Village of Arlington Heights
Plan Commission
Board Room
Arlington Heights Village Hall
33 S. Arlington Heights Road
Arlington Heights, IL 60005
November 8, 2017
7:30 PM

- A. Hey Nonny - 10 S. Vail Ave. - PC#17-011
PUD Amendment, Special Use for Restaurant/Auditorium (Music Venue), Variation to waive traffic study.

PC File Number: PC 17-011
Project Title: Hey Nonny
Address: 10 S. Vail Avenue.
PIN: 03-29-346-036

Petitioner's Justification for Variation From Parking and Traffic Study Requirements

SHEET:
A-100

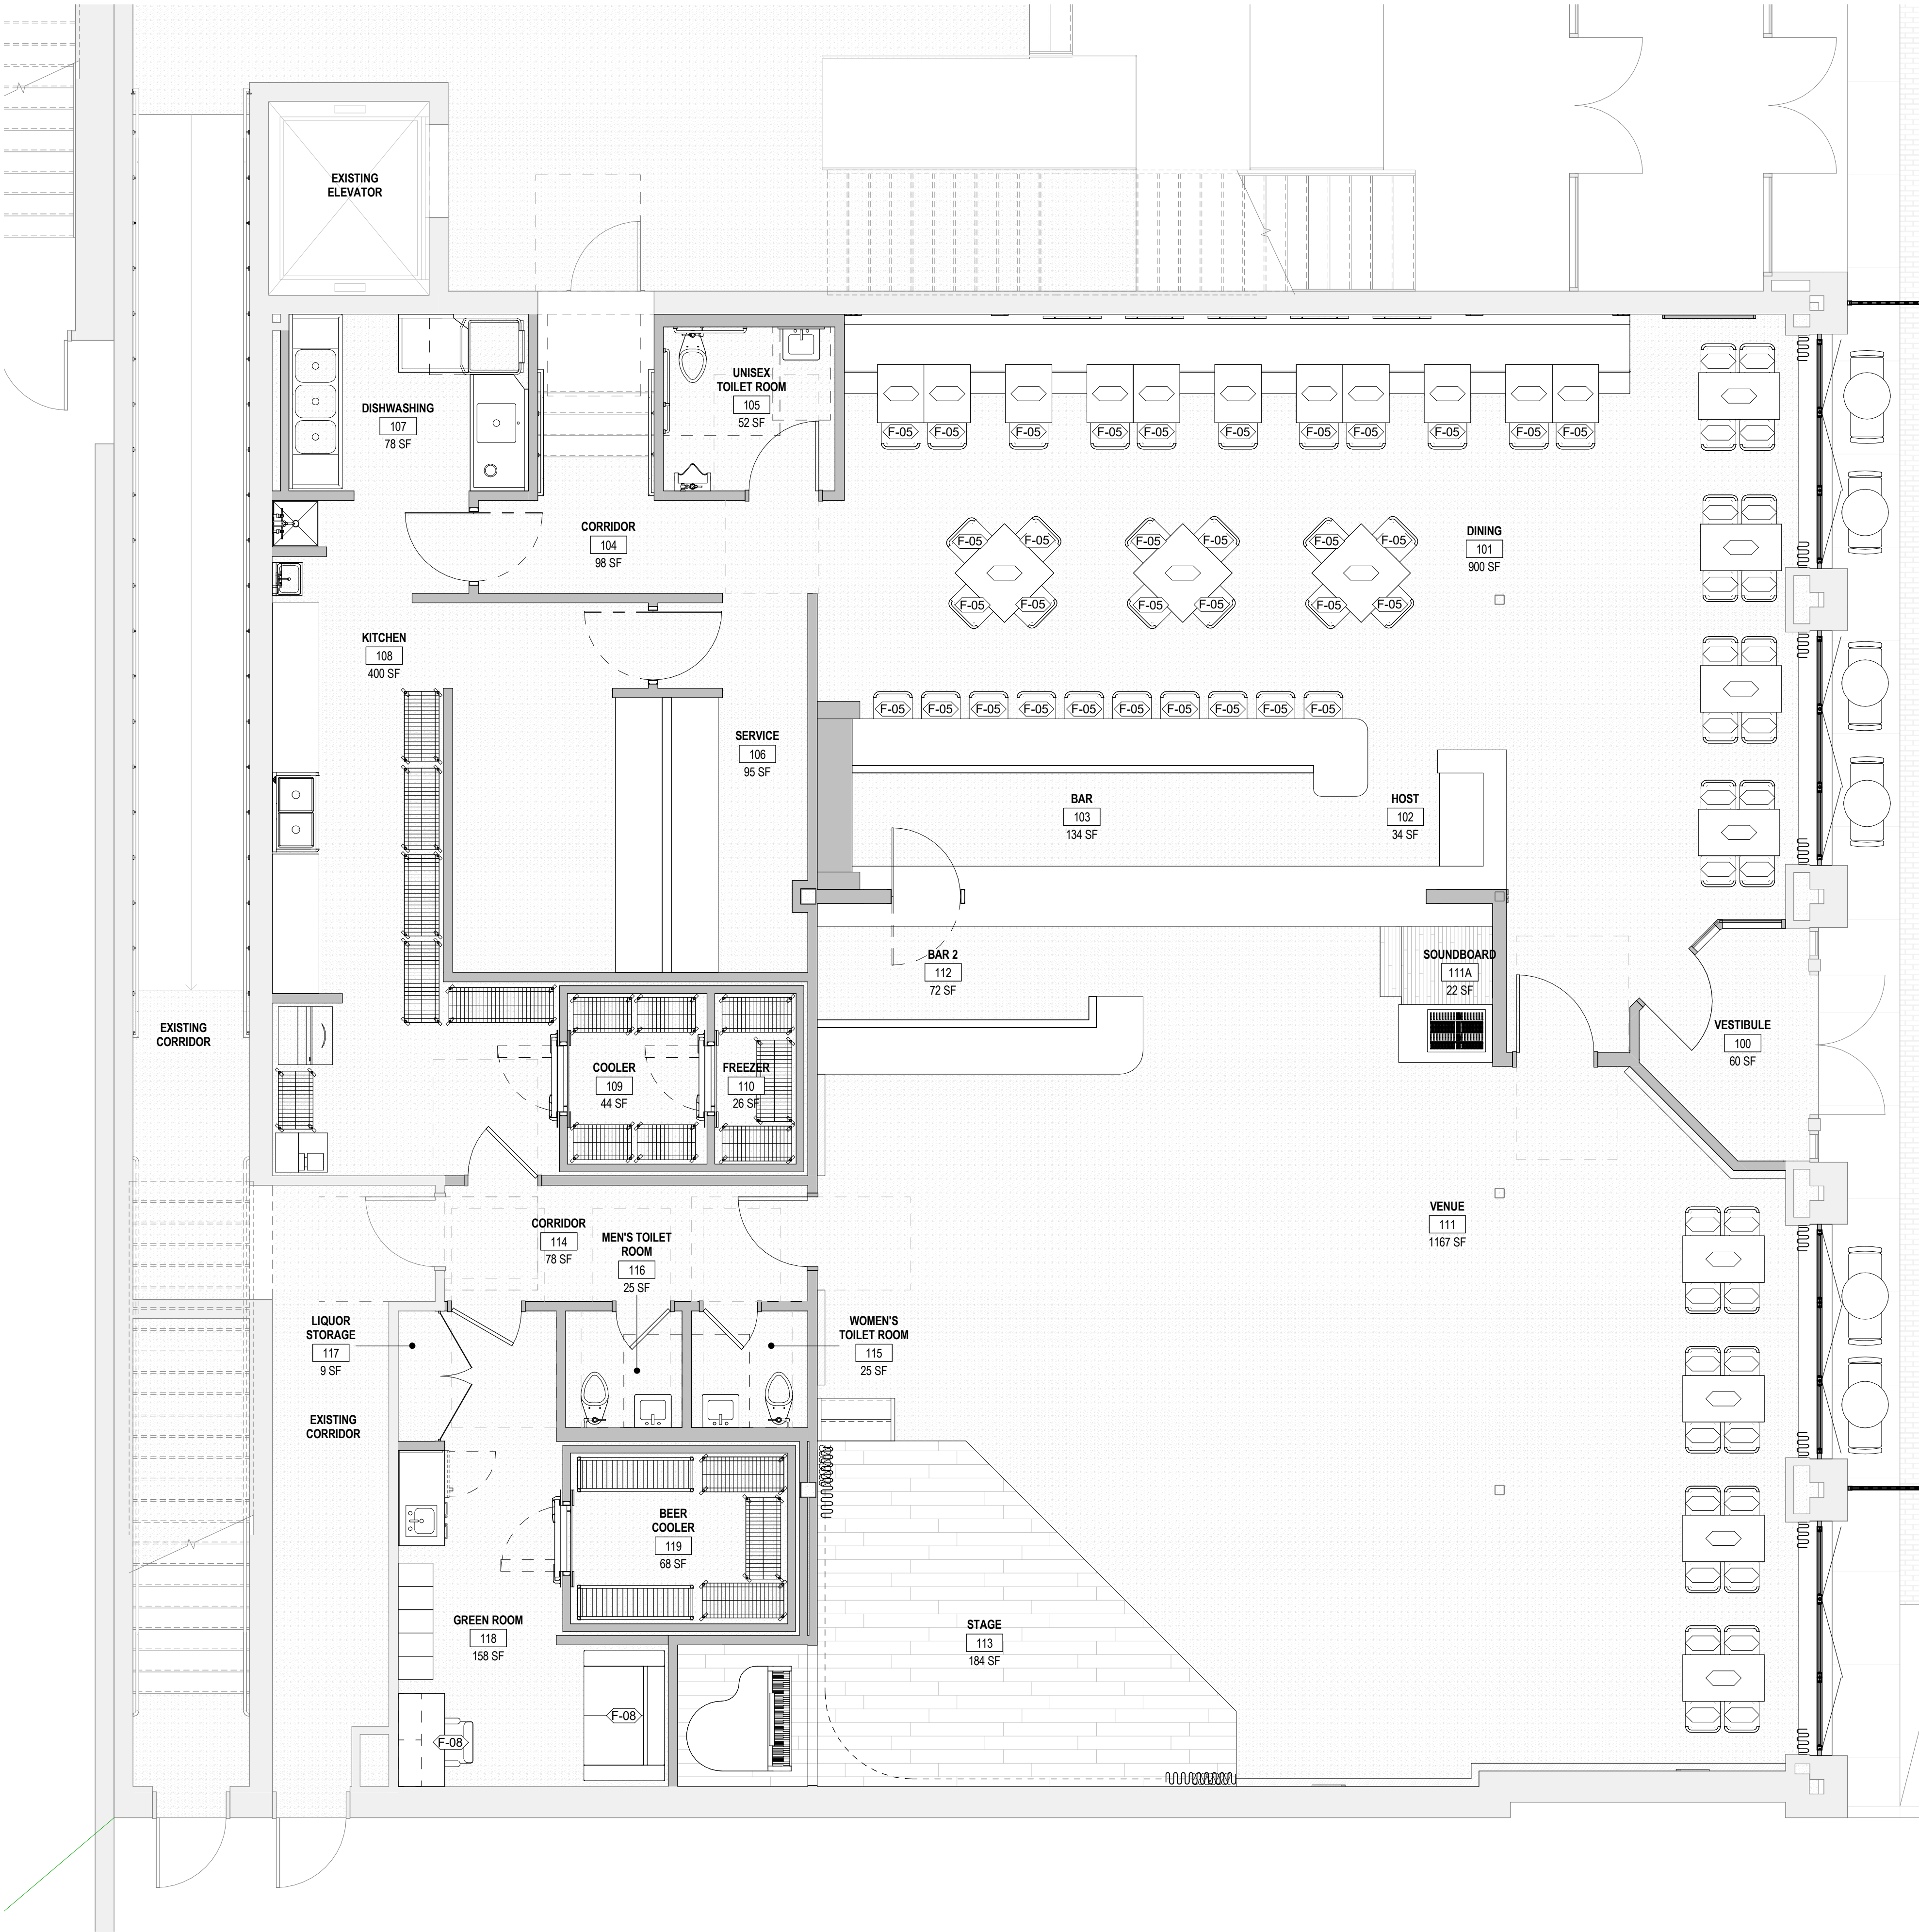
12. The square footage of each area on the floor plans do not match. Specifically, the "Proposed Floor Plan" (Sheet A-100) shows different square footage sizes as compared to the "Revised First Floor Space Plan (Sheet Sk-01.2). Please confirm which plan is accurate with relation to overall square footage and make revisions as necessary.

RESPONSE: Please refer to sheets A-001 and A-100 in the resubmitted documents for the current square footage(s) of the spaces in the proposed establishment. The likely variation between plans referenced in the question above had to do with values not being updated in the SK-01.2 space plan compared to the more recent A-100 plan.

A-001

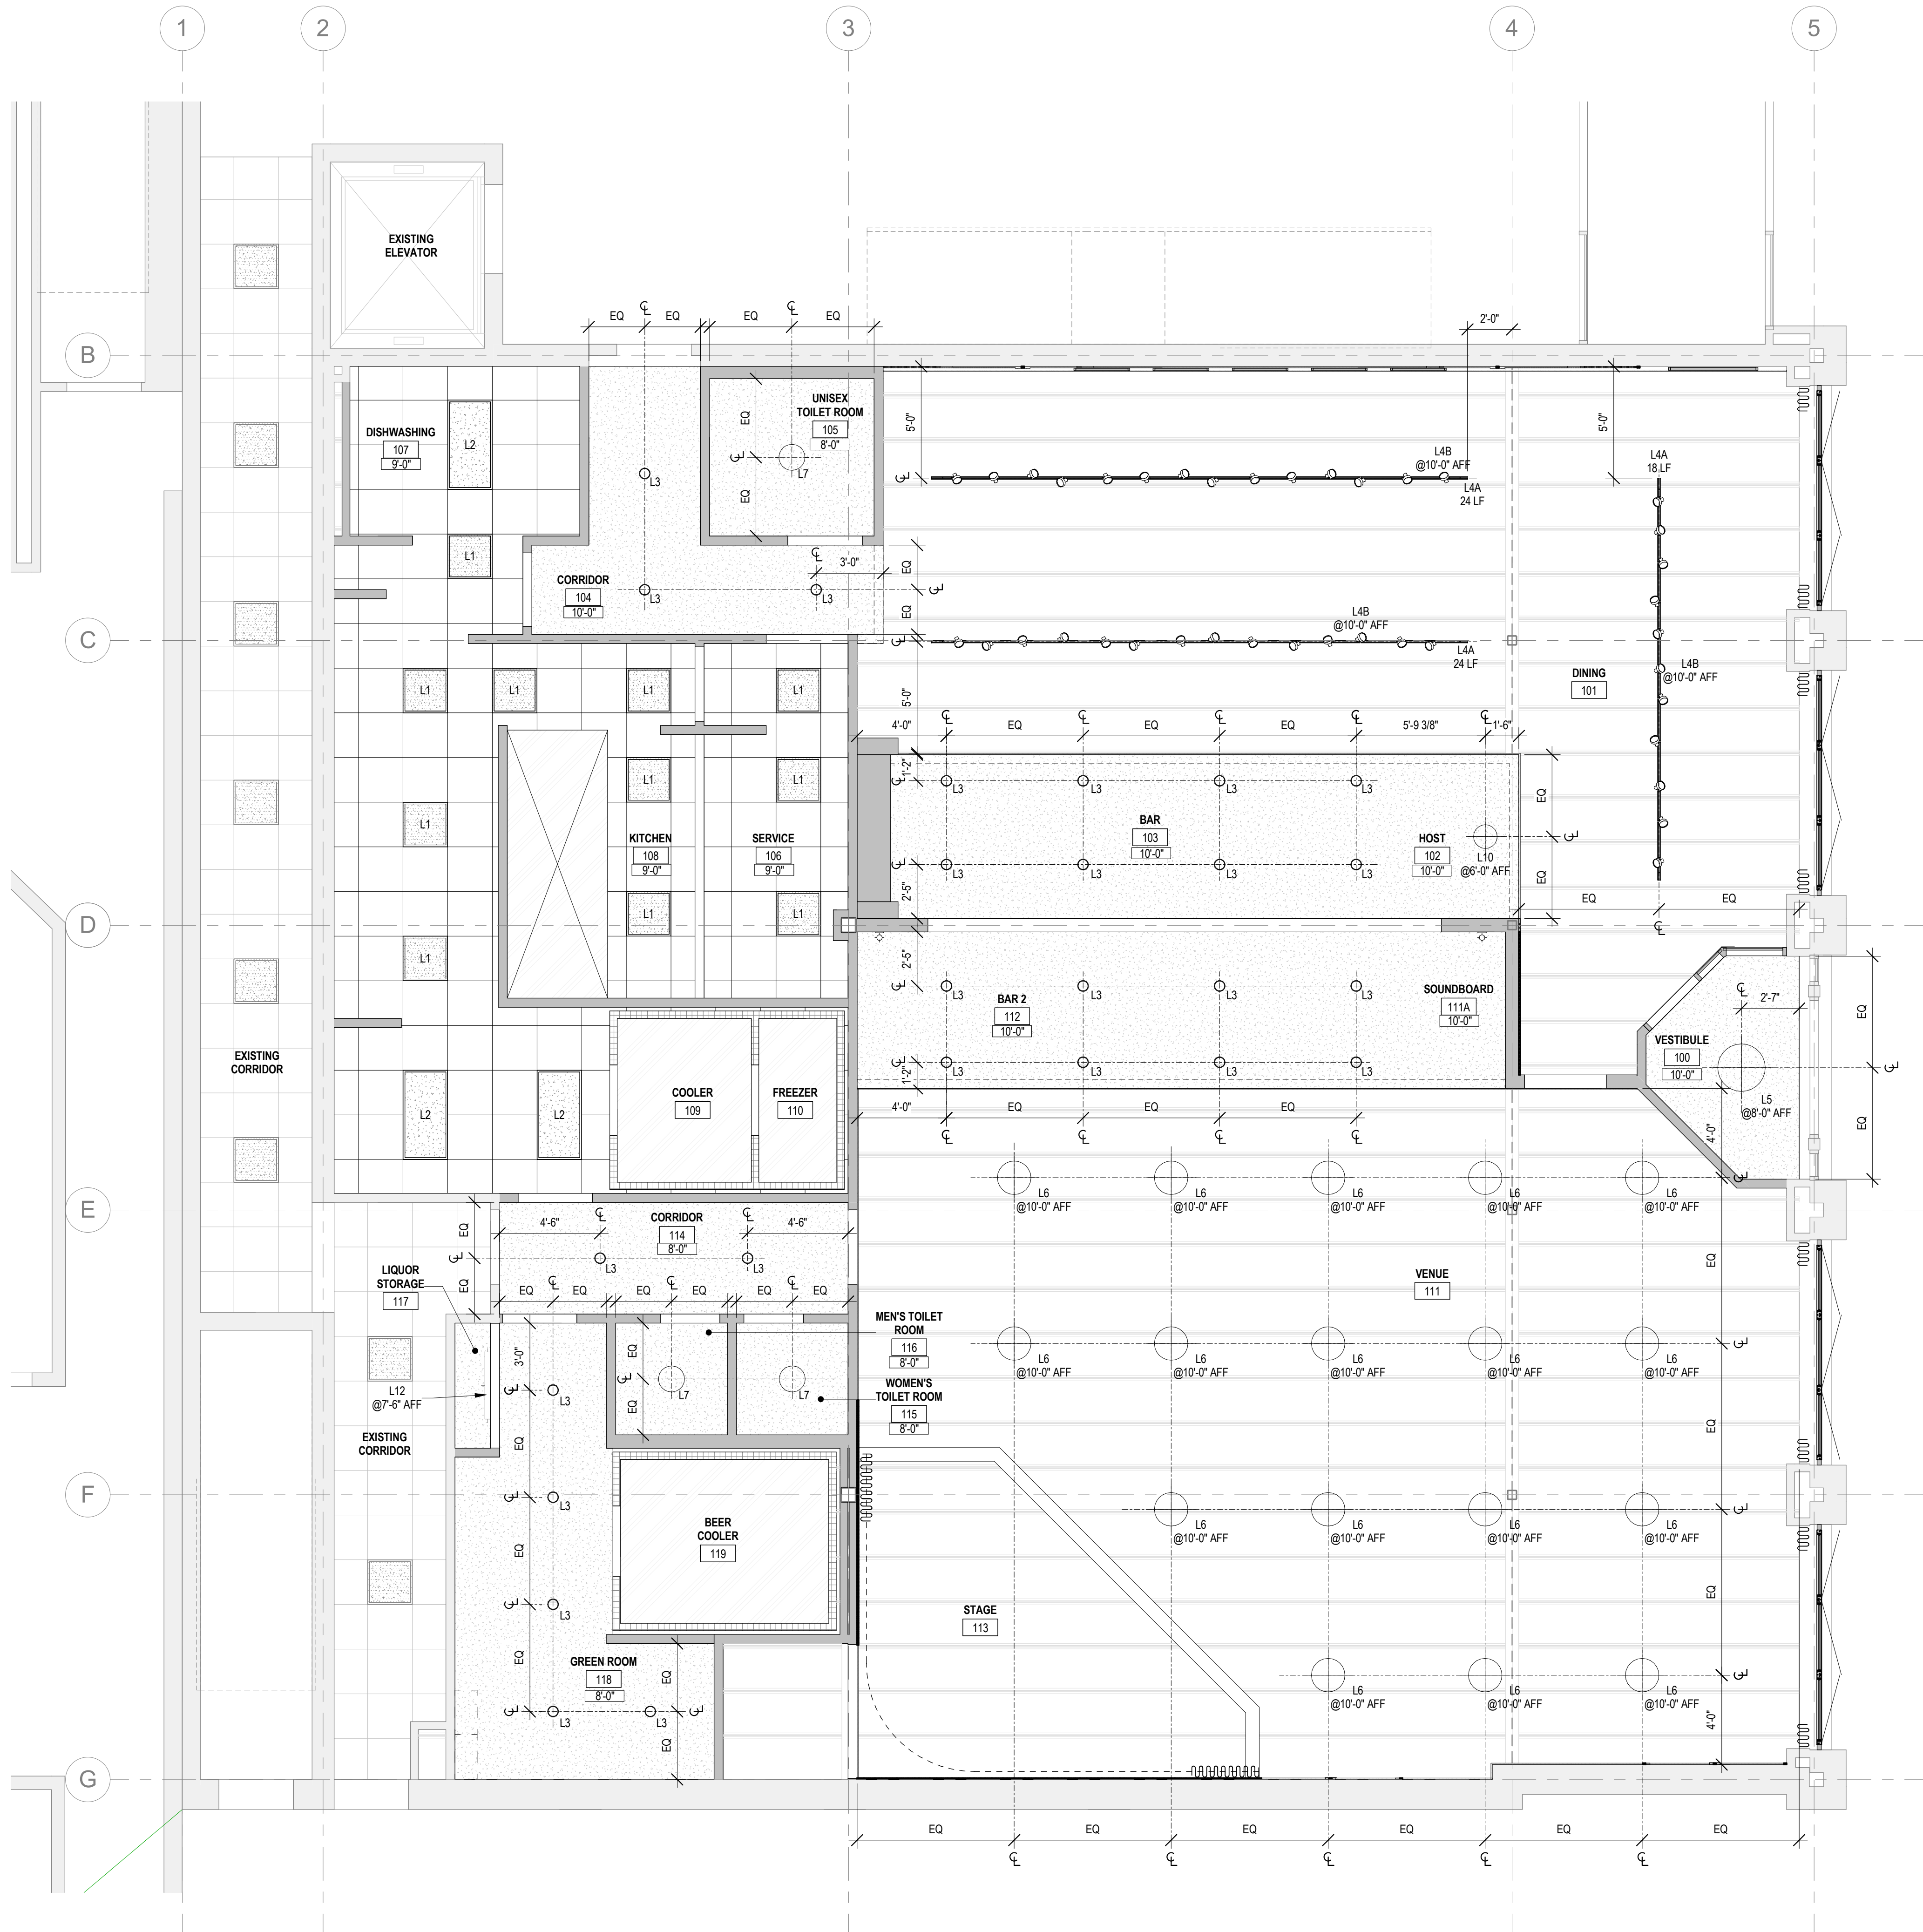
11. The Plat of Condominium shows that the space is 3,974 sq. ft. in area. Please have the architect include this information on the floor plan.
12. The square footage of each area on the floor plans do not match. Specifically, the "Proposed Floor Plan" (Sheet A-100) shows different square footage sizes as compared to the "Revised First Floor Space Plan" (Sheet Sk-01.2). Please confirm which plan is accurate with relation to overall square footage and make revisions as necessary.

RESPONSE: Refer to sheet A-001 in the submitted drawings for specific exit locations, occupant load and travel distance. There are (2) exits with a maximum capacity of 180 occupants per exit. Each exits' actual capacity, based on the occupant load of the space being 259 occupants, is 130 occupants.
